BCA DESIGN REPORT – REF REVIEW

To:	ADCO	Project #	220004
Attention:	Kelsey Godwin-Smith	Date:	30 August 2022
Email:	kelseyg@adcoconstruct.com.au	Pages:	24
From:	David Martin		
Subject:	REF Design – STAGE 2 Community Health Building Alterations (CHB) [Building 33] - Griffith Base Hospital (GrBH) – Revision 1

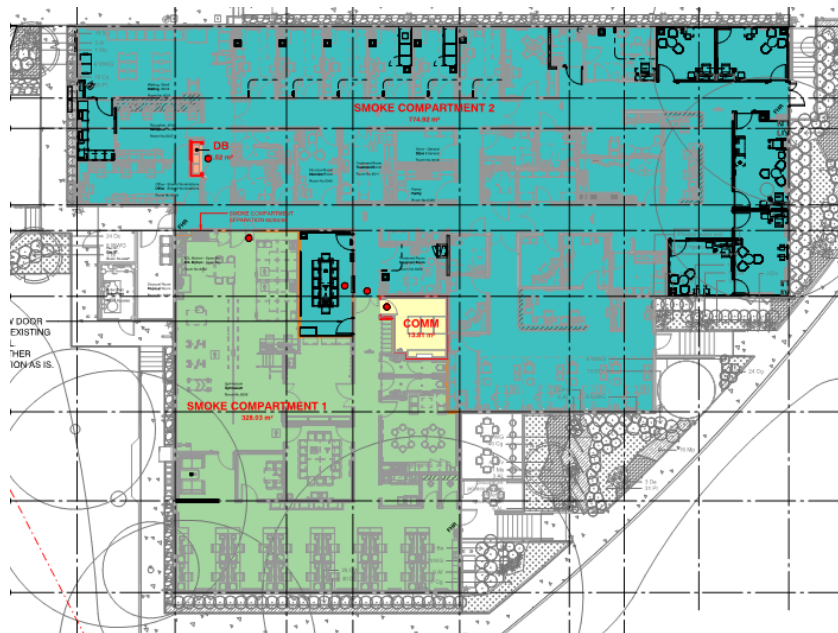
Details of existing and new compartment sizes (smoke & fire) are currently noted on the drawings. See comments below:-

CHB Compartmentation - 60/60/60 FRL smoke wall as shown above to be maintained.

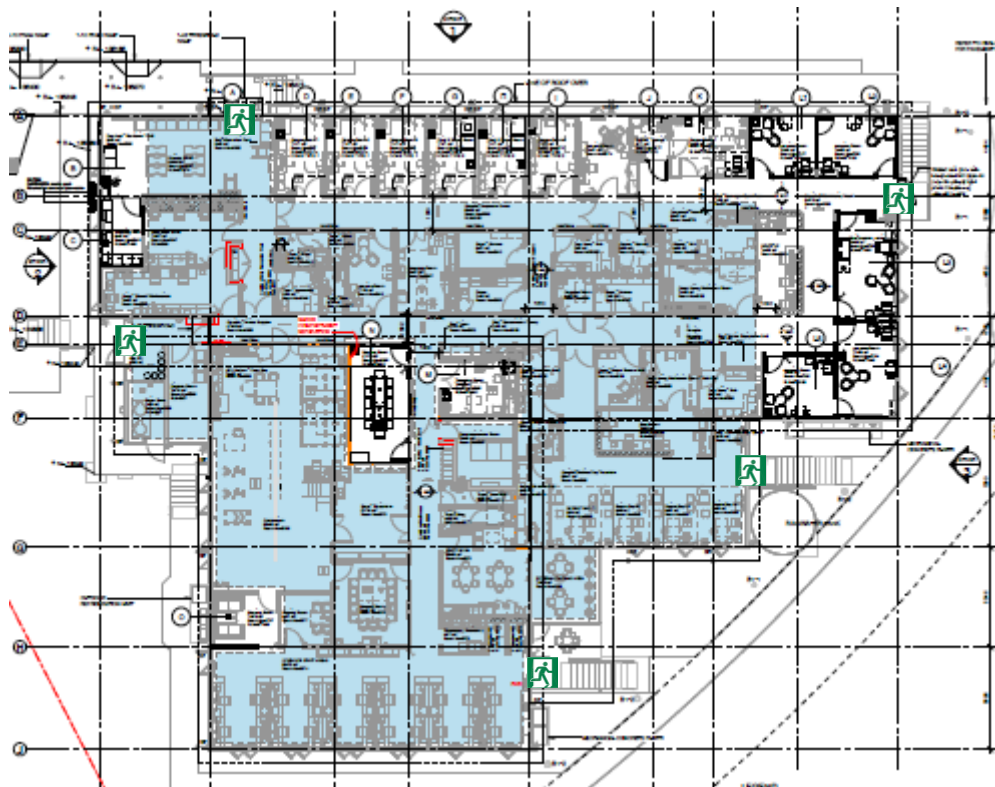
Egress is generally compliant throughout the respective buildings – exits are noted as below:-

Within the CHB a number of the compartment doors swing against egress direction and will need to be addressed in the FER.
